**Issue Specific Hearing 11 (ISH11) on Flooding, Water and Coastal Processes
Theberton and Eastbridge Parish Council, Stop Sizewell C and Minsmere Levels
Stakeholders Group**

Oral Contribution by Cllr. Paul Collins

Figure 1: Sizewell A & B Salient apices and shingle bank

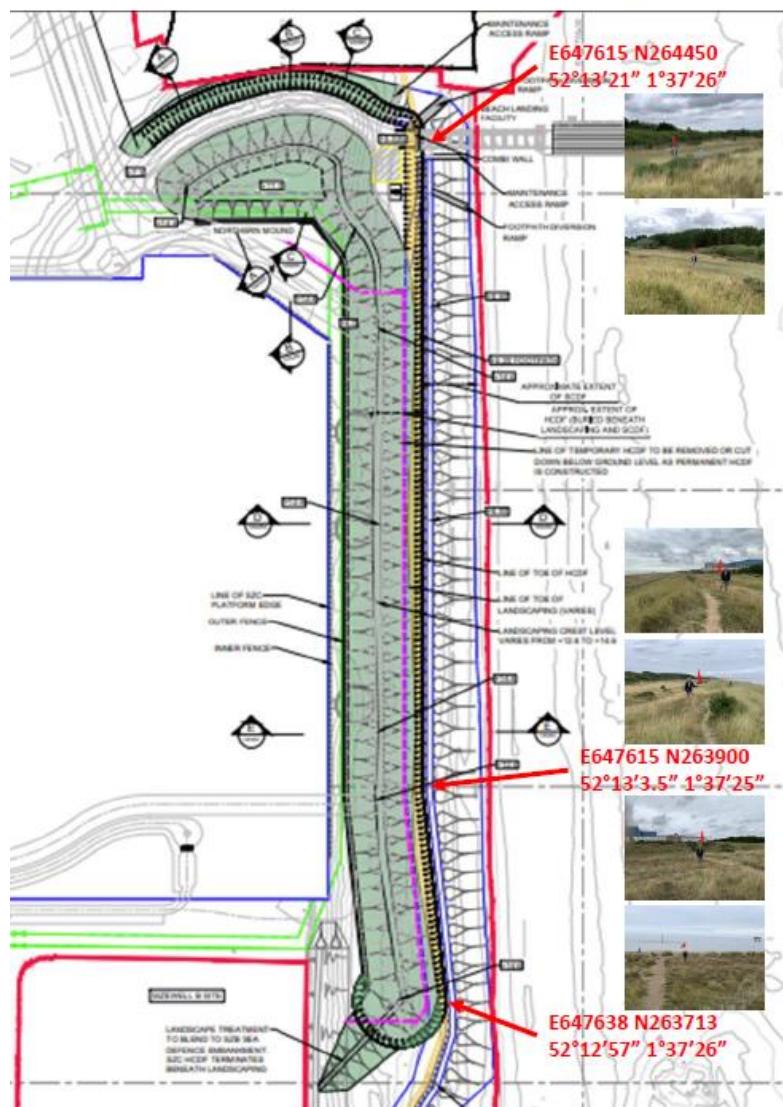
The expected relaxation of the shoreline when Sizewell B enters its decommissioning phase (which was also observed when Sizewell A stopped operating), may also reduce erosion pressure immediately north of the HCDF, due to gross transport during SE events and trapping of some material to the immediate north of the HCDF
- *However, the remains of the salient at Sizewell A is still visible in Sizewell Bay having been protected by the Sizewell B salient against the predominant north-south longshore drift as shown in this photograph taken on 18th September 2021 and in the long-distance photographs of Sizewell Bay below (Figures 2 & 3).*

- So, this part statement seems to be without foundation and does not reflect the reality on the current shoreline. The final statements regarding trapping of materials north of the HCDF may no longer be supportable given the change in position, landward, of the permanent Beach Landing Facility.

- We were taken by surprise when we made our way to the most south-eastern point as we found ourselves some 15-20 metres seaward of the current sacrificial dune on the vegetated shingle between a viewing platform, that sits on the top of the sacrificial dune, and directly in line with the SZB inlet and outfall positions (**just to the right of the SZB salient position shown in the photograph above**).
